Intersection ID: 27461	Main Street: BRUSH_HOLLOW_RD	Cross Street: FAWN_HILL_RD	Location:	N
ADA ID: 72B330AD9879	Ramp Type: Perp	Initial Pass/Fail: Fail	Overall Compliance: No	Severity Score: 8.75

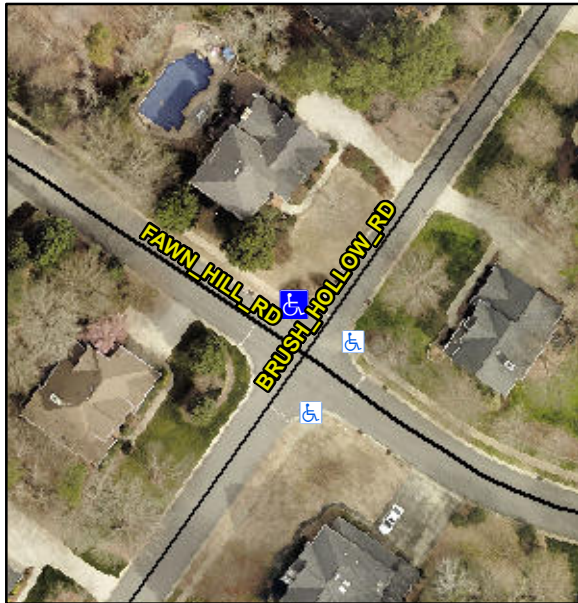
**Not Found, R304.5.1**

Compliance	Description	Data	Compliance	Description	Data
N/A	Ramp Length (in)	60.0	Yes	Ramp Slope (%)	5.7
No	Ramp Width (in)	47.0	Yes	Ramp XSlope (%)	1.6
N/A	Flare Type LT	N/A	N/A	Flare Type RT	N/A
N/A	Flare Slope LT (%)	N/A	N/A	Flare Slope RT (%)	N/A
N/A	Flare Traversable LT?	N/A	N/A	Flare Traversable RT?	N/A
N/A	Landing Length (in)	N/A	N/A	DWS Provided?	N/A
N/A	Landing Width (in)	N/A	N/A	DWS Contrast?	N/A
N/A	Landing Slope (%)	N/A	N/A	DWS Length (in)	N/A
N/A	Landing X Slope (%)	N/A	N/A	DWS Full Width?	N/A
N/A	Landing Curb? (Y/N)	N/A	N/A	DWS Offset (in)	N/A
N/A	Shared Landing?	N/A			
N/A	Gutter Ponding?	N/A	N/A	Gutter Slope (%)	N/A
N/A	Gutter Lip Ht (in)	N/A	N/A	Gutter X Slope (%)	N/A
N/A	Painted X Walk1?	No	N/A	Painted X Walk2?	N/A
	X Walk 1 Direction	To SE		X Walk 2 Direction	N/A
N/A	X Walk 1 Width (in)	N/A	N/A	X Walk 2 Width (in)	N/A
	X Walk 1 Slope (%)	4.2		X Walk 2 Slope (%)	N/A
	X Walk 1 X Slope (%)	1.3		X Walk 2 X Slope (%)	N/A

### Remove & Replace Entire Ramp.
